PROJECT NO. R-2514D  
JONES & CRAVEN COUNTY  
 STATION: 428+53.58 -L-  
 = 13+04.09 -Y5-

STATE OF NORTH CAROLINA  
 DEPARTMENT OF TRANSPORTATION  
 RALEIGH  
 SUPERSTRUCTURE  
**FRAMING PLAN &  
 DEAD  
 LOAD DEFLECTIONS**  
**-RIGHT LANE-**

REVISIONS						SHEET NO. S10-10
NO.	BY:	DATE:	NO.	BY:	DATE:	
1	STV	4-15	3			TOTAL SHEETS 24
2			4

FRAMING PLAN - SPAN A

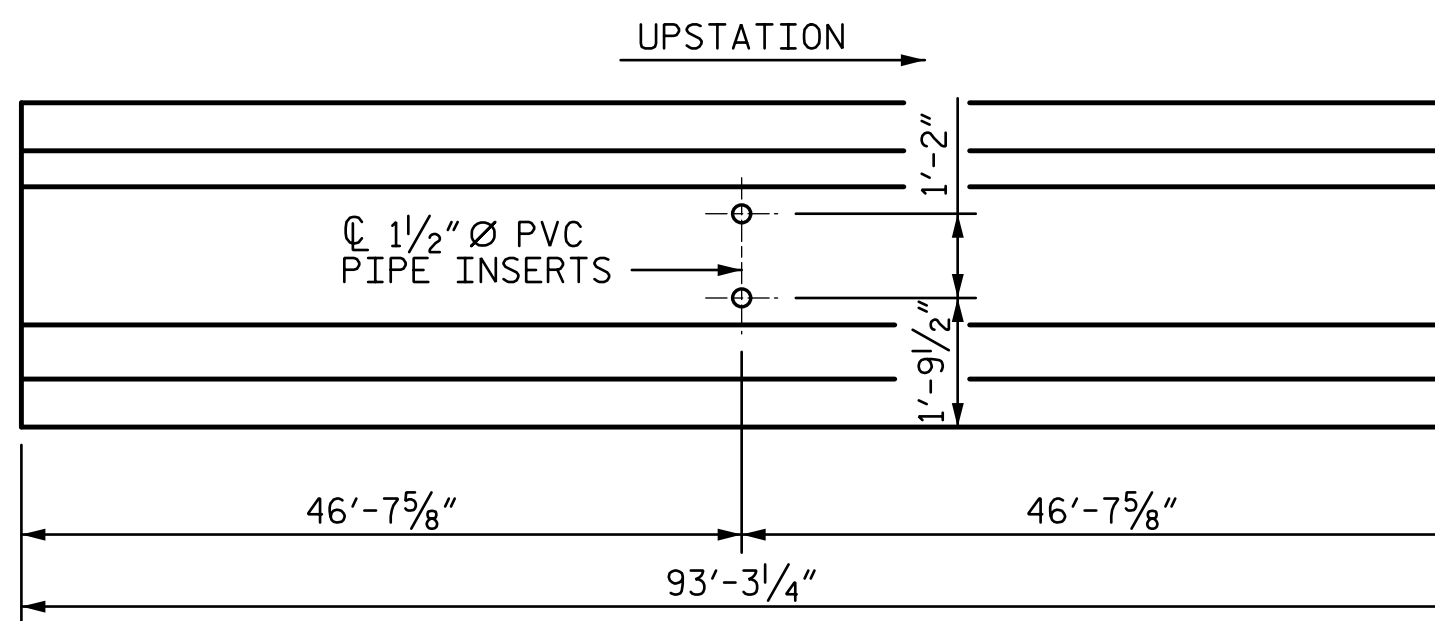
△ DEAD LOAD DEFLECTION TABLE											
TENTH POINTS	SPAN A						GIRDERS 1 & 5				
	CAMBER (GIRDER ALONE IN PLACE)	0.000	0.096	0.166	0.212	0.238	0.247	0.238	0.212	0.166	0.096
DEFLECTION DUE TO SUPERIMPOSED D.L.	0.000	0.033	0.064	0.089	0.105	0.110	0.105	0.089	0.064	0.033	0.000
FINAL CAMBER	0"	3/4"	1 3/16"	1 1/2"	1 5/8"	1 5/8"	1 5/8"	1 1/2"	1 3/16"	3/4"	0"

△ DEAD LOAD DEFLECTION TABLE											
TENTH POINTS	SPAN A						GIRDERS 2-4				
	CAMBER (GIRDER ALONE IN PLACE)	0.000	0.096	0.166	0.212	0.238	0.247	0.238	0.212	0.166	0.096
DEFLECTION DUE TO SUPERIMPOSED D.L.	0.000	0.034	0.068	0.094	0.111	0.117	0.111	0.094	0.068	0.034	0.000
FINAL CAMBER	0"	3/4"	1 3/16"	1 1/16"	1 1/2"	1 3/16"	1 1/2"	1 1/16"	1 3/16"	3/4"	0"

△ REVISED PER NCDOT COMMENTS
